भारतीय लघु उद्योग विकास बैंक
Small Industries Development Bank of India

Tender No. and Date	400/2018/1310/BYO/ITV Dated January 30, 2018
Purpose	Request for Proposal for Co-location of Bank's DataCenter and Disaster Recovery Site
Pre-bid Meeting held on	February 07, 2018

Clarifications to Pre-bid Queries

Data Center Inter-rack Cabling Layout

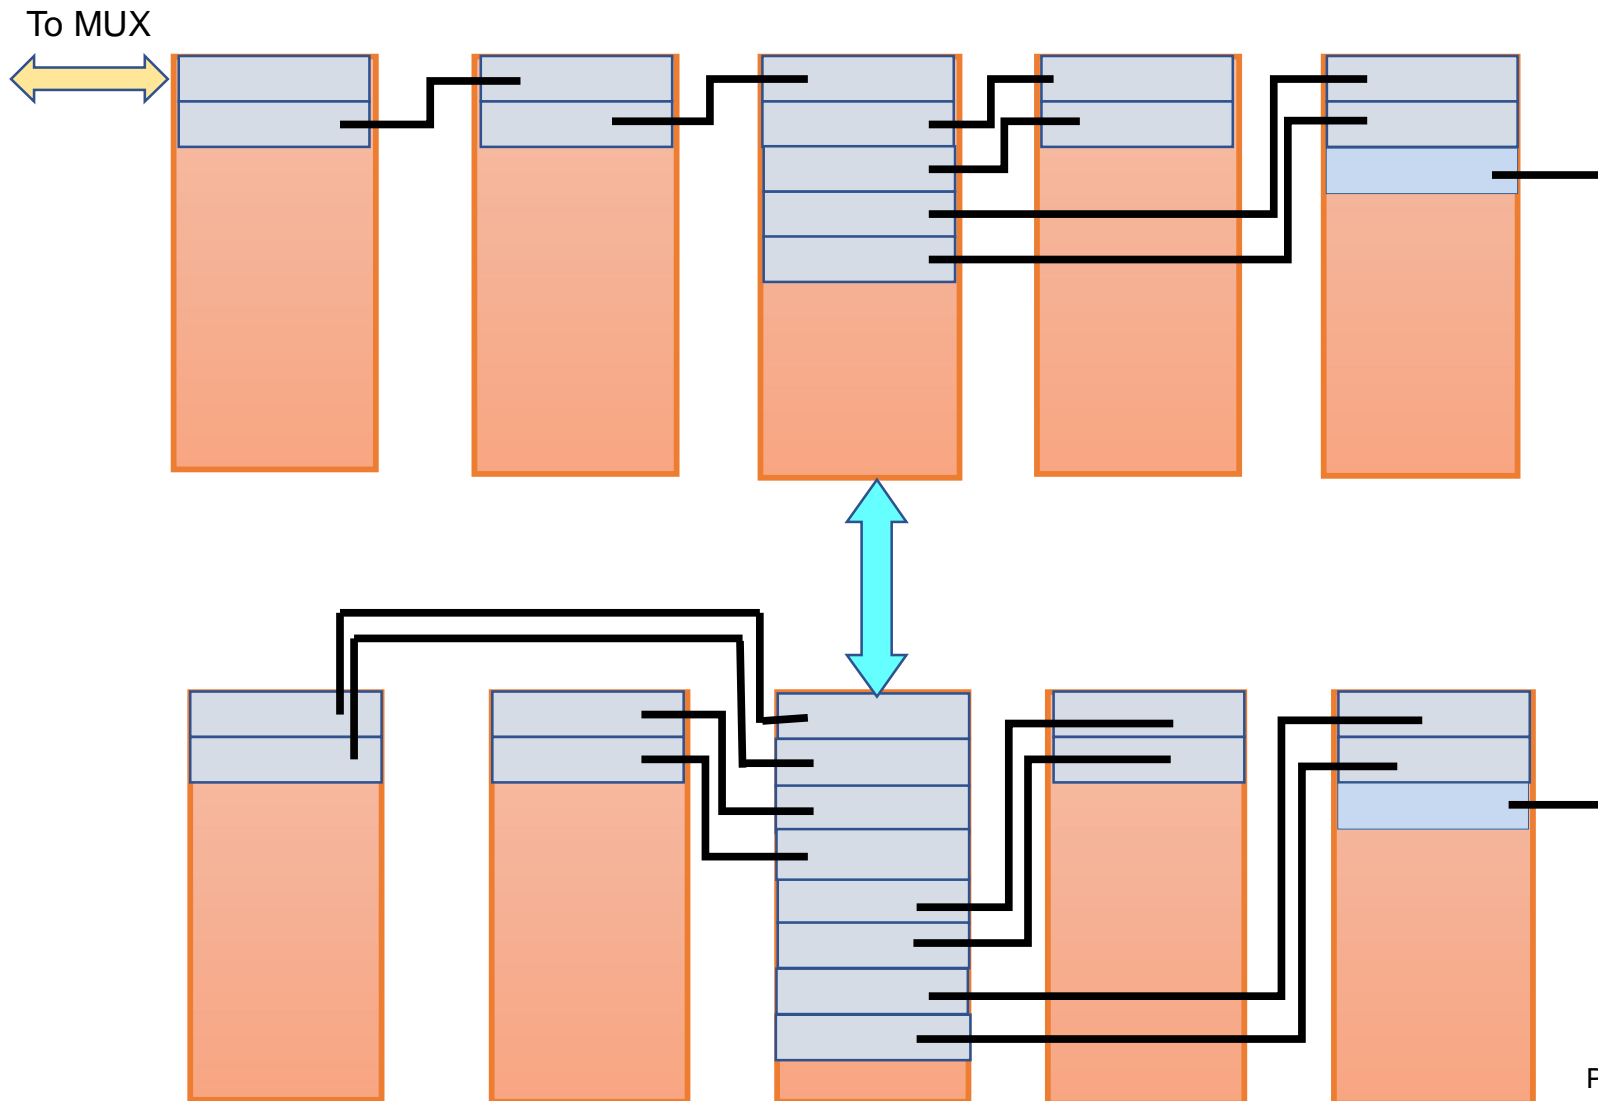
14	15	5.7.4	The VENDOR should provide racks of 42U size with inter-rack cabling, cross connects to communication area. The racks should have proper cable managers (vertical and horizontal) and troughs for complete structured cabling. Blanking panels etc., if required as per Industry best practice to be provided. The VENDOR shall provide adequate power points of required specifications in the racks with redundant UPS power.	Inter-rack cabling - Scope Defined	Inter-rack cabling architecture attached herewith as Appendix i.

22	16	5.7.19	Single phase and three phase power should be made available to support the Bank's equipment's in the server / cage area. The detailed numbers will be provided to VENDOR after award of the contract.	Please quantify rack wise commando socket requirement along with Rack wise rated power information as inventory which shared in RFP.	1. All the racks to be provided with single phase power. 2. In case during the period of contract the Bank desires to have three phase power, the bidder to provide the same at the contracted rate.
23				No of single & three phase power supply	
24	16	5.7.20	The VENDOR shall provide one-time LAN cabling (and thereafter maintenance of same), interconnecting all the racks, from the Network rack to the Server Racks as per the network design provided by the Bank.	Interconnection of network & server Racks - Provide the network design	The network diagram showing interconnect between the racks is given in Appendix-i.
